## ADDENDUM 4

DATE: November 30, 2016  
 PROJECT: MSB First Floor Infill LRC 3 & 4  
 RFP NO: 744-R1705  
 OWNER: The University of Texas Health Science Center at Houston  
 TO: Prospective Proposers

This Addendum forms part of and modifies Proposal Documents dated, October 19, 2016, with amendments and additions noted below.

**Partition Types and Interior Construction Details**

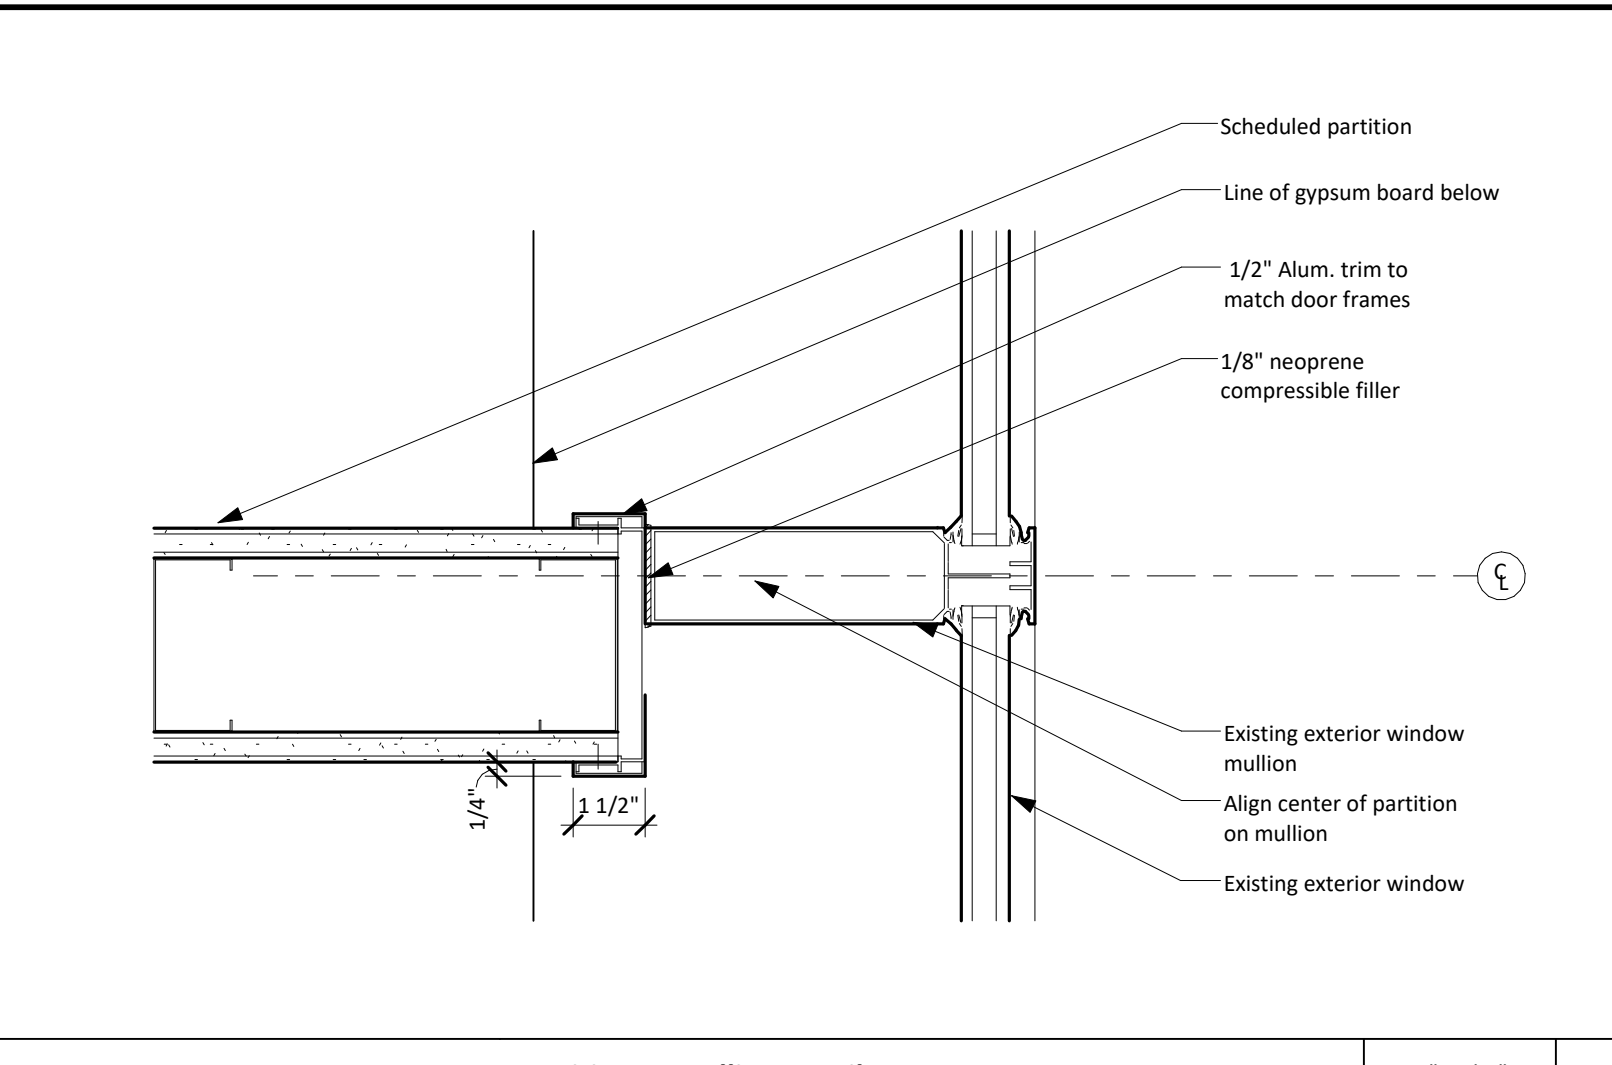
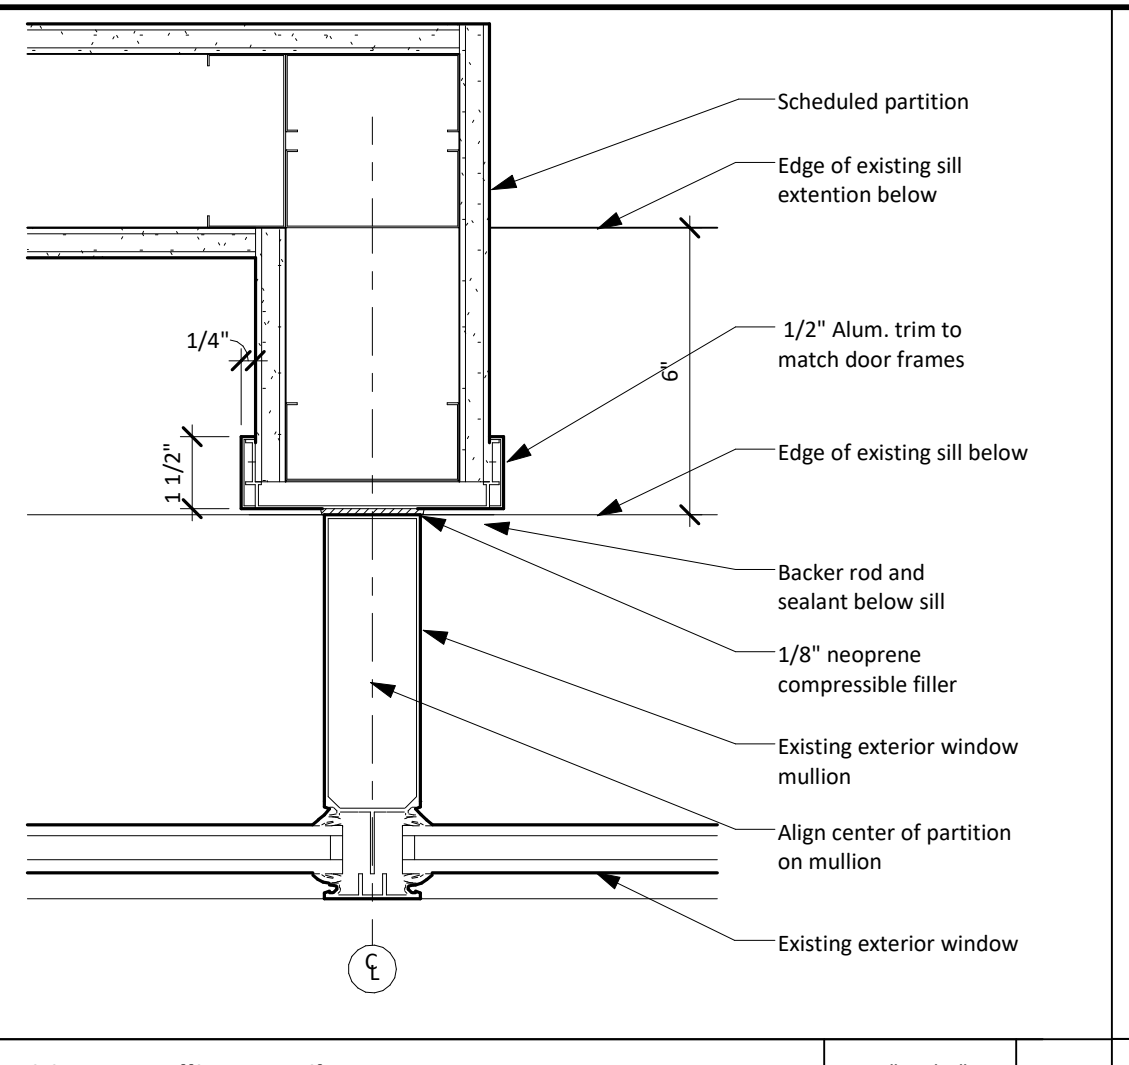
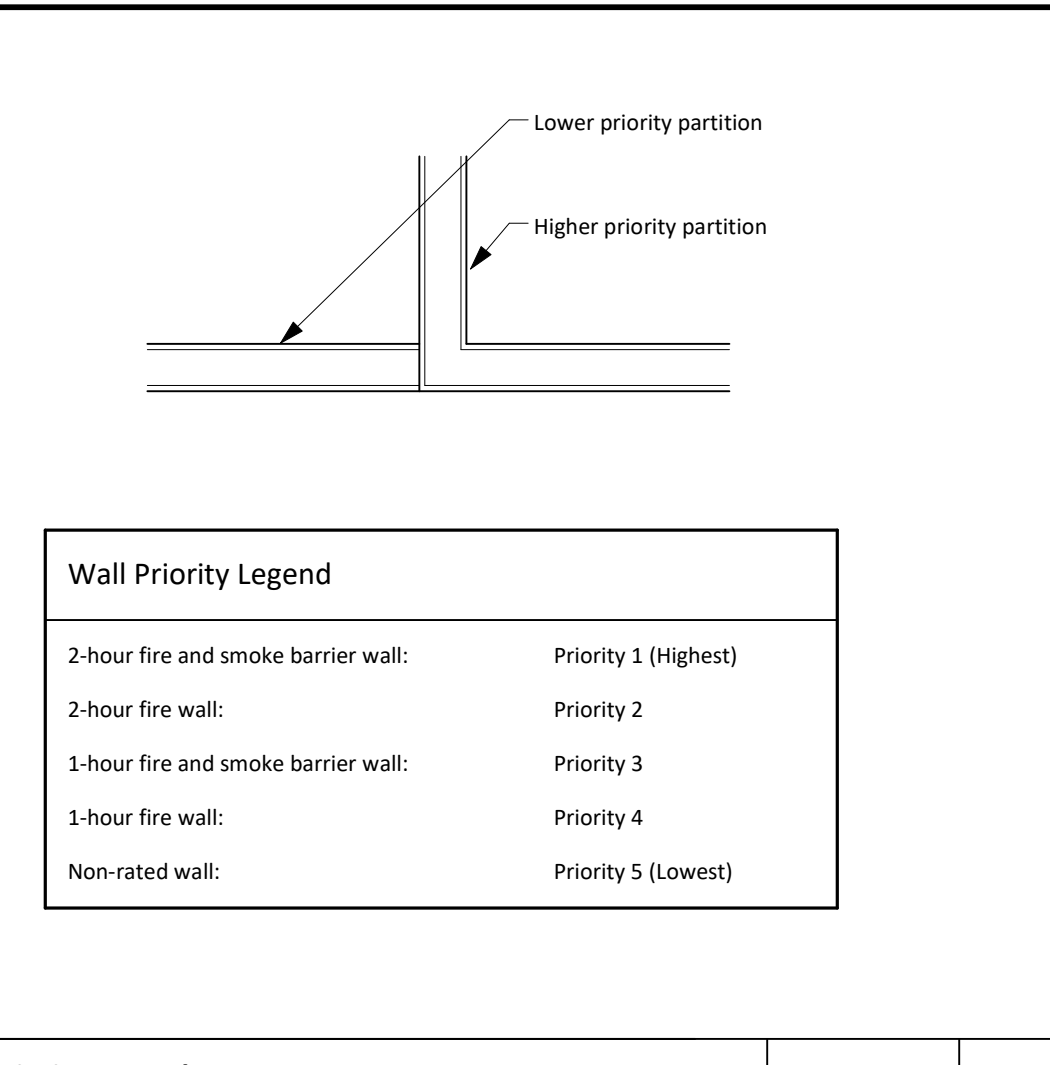
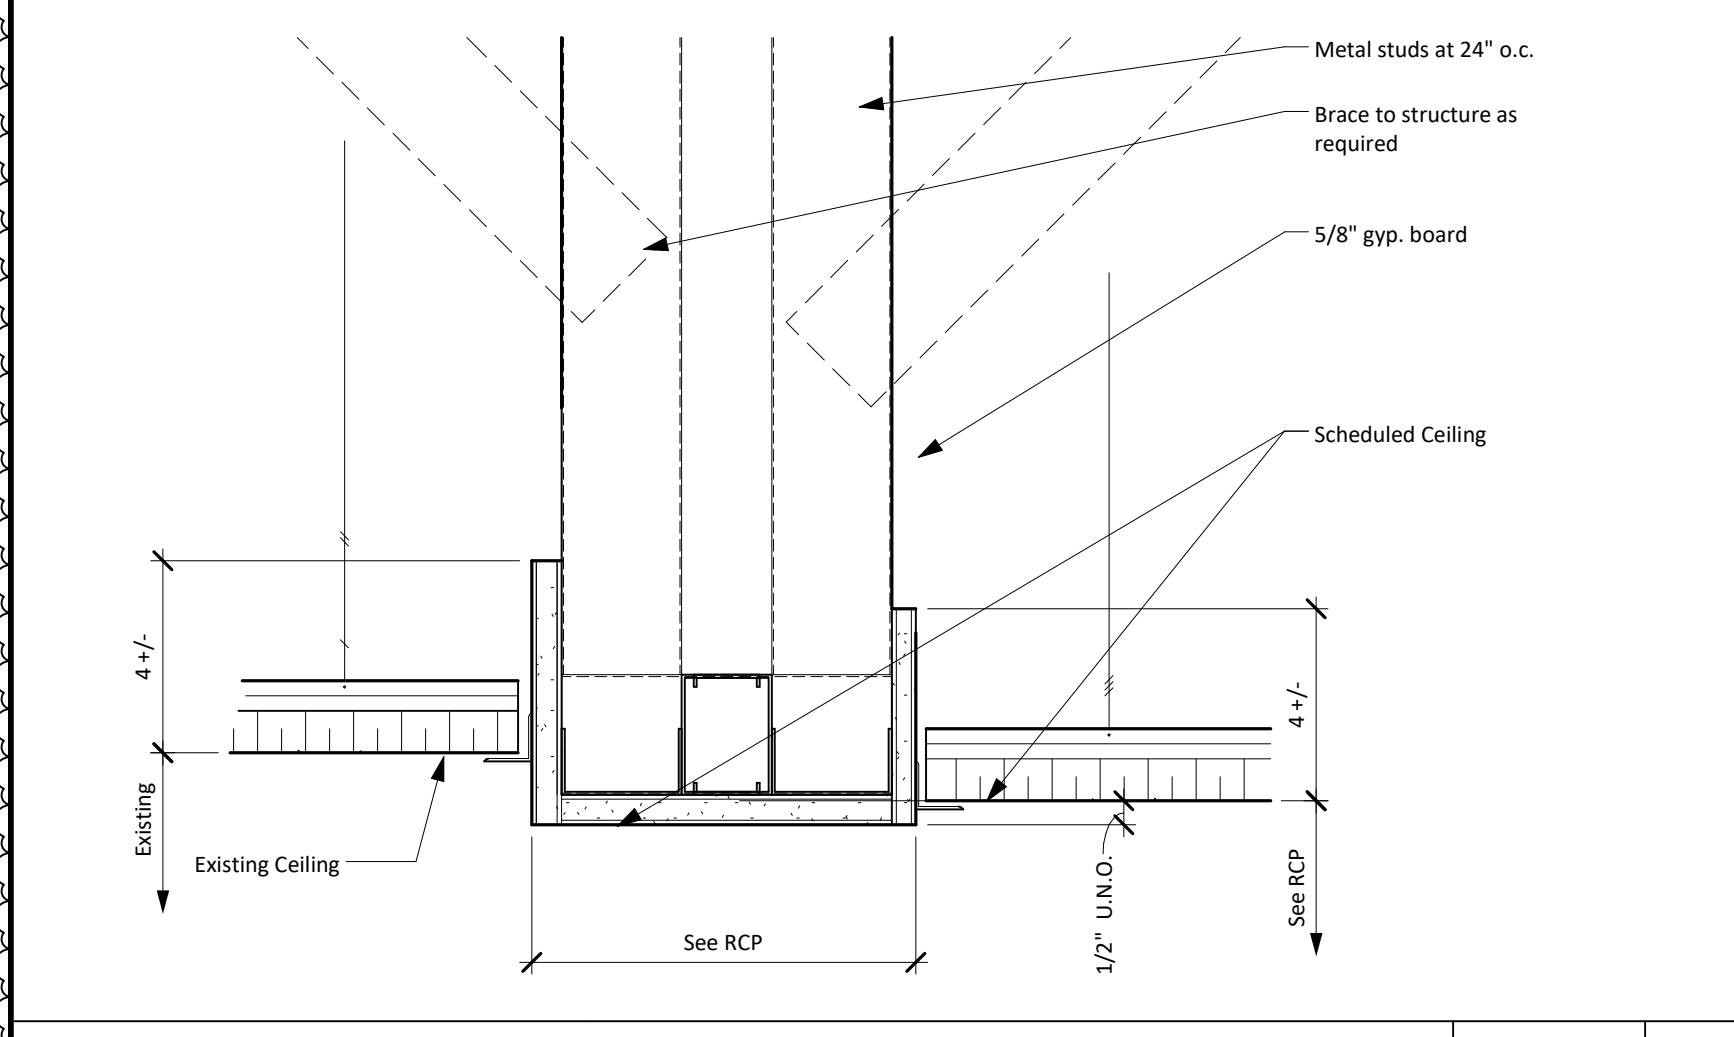
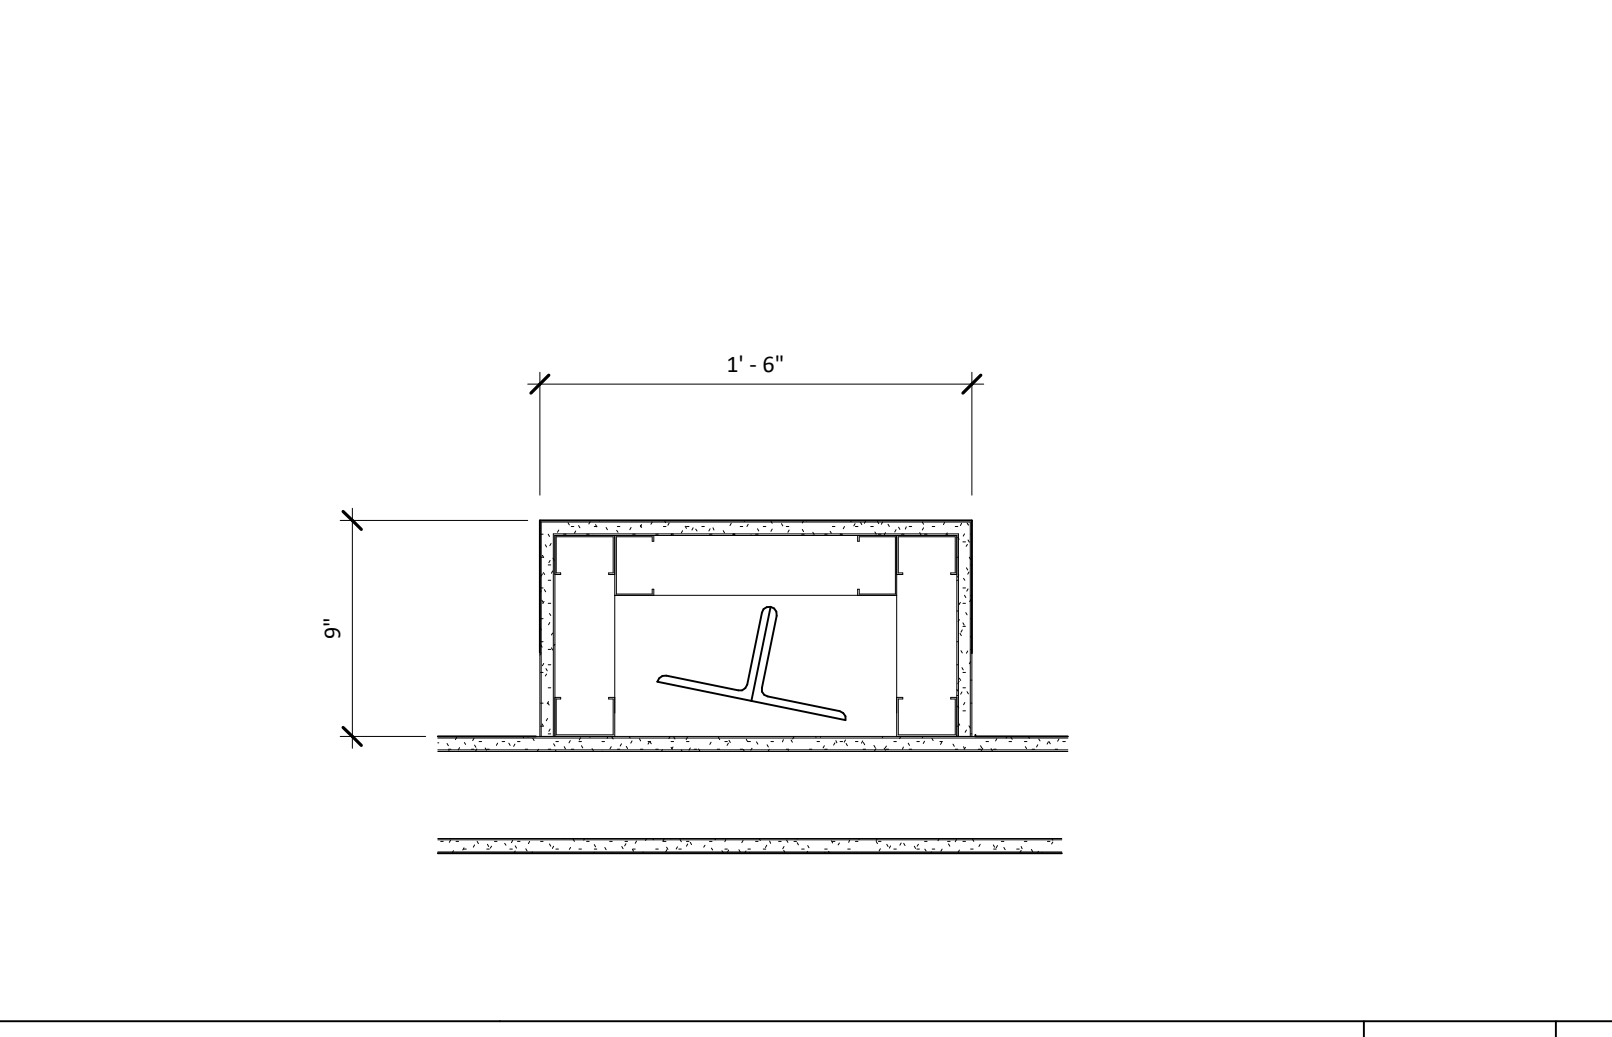
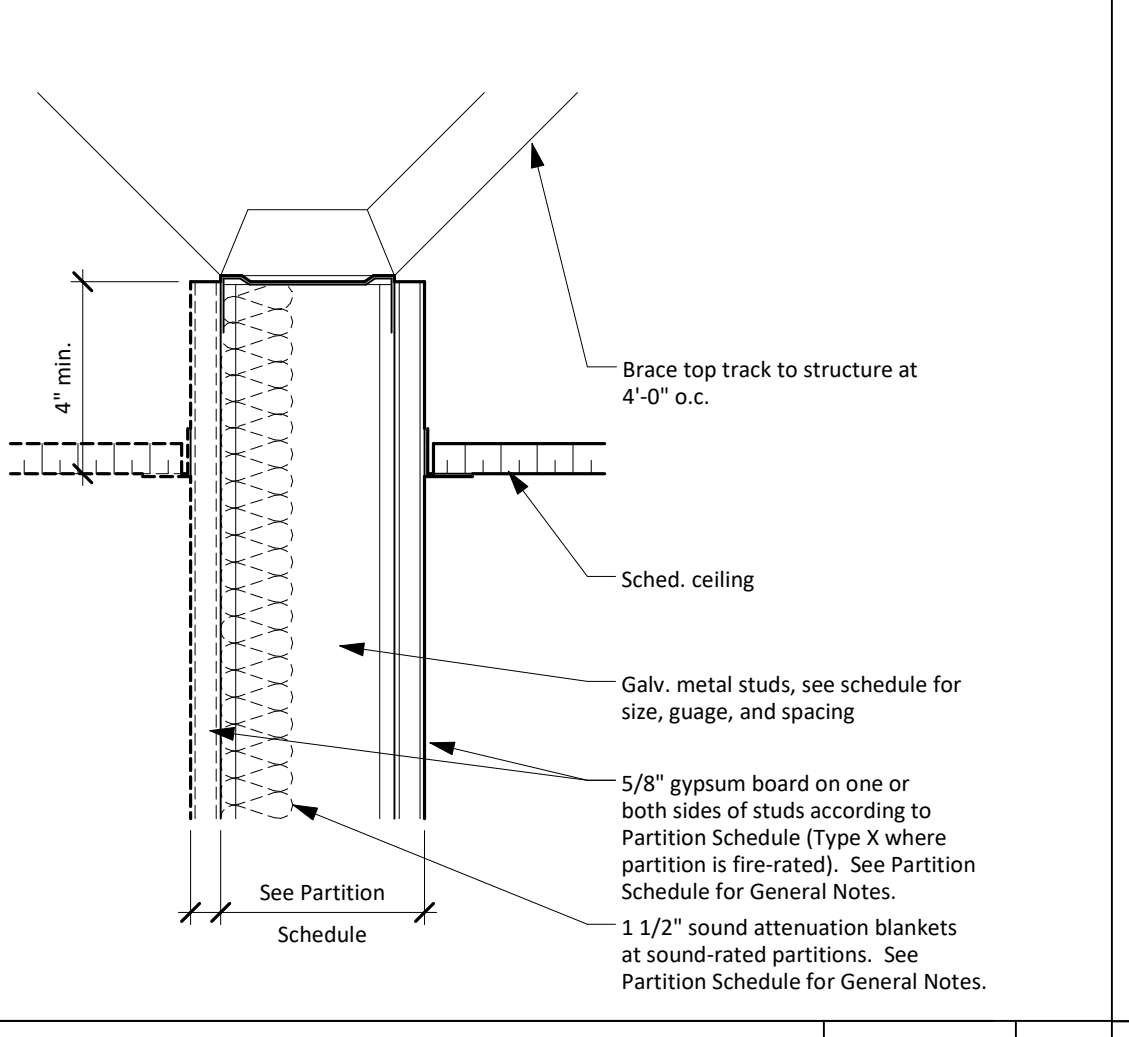
5. Please confirm whether the new column wraps are to be fire rated at the steel connection plates along column lines A & H.  
**Column gyp wraps are to be (2) two hour fire rated. See Addendum 4 drawings below.**
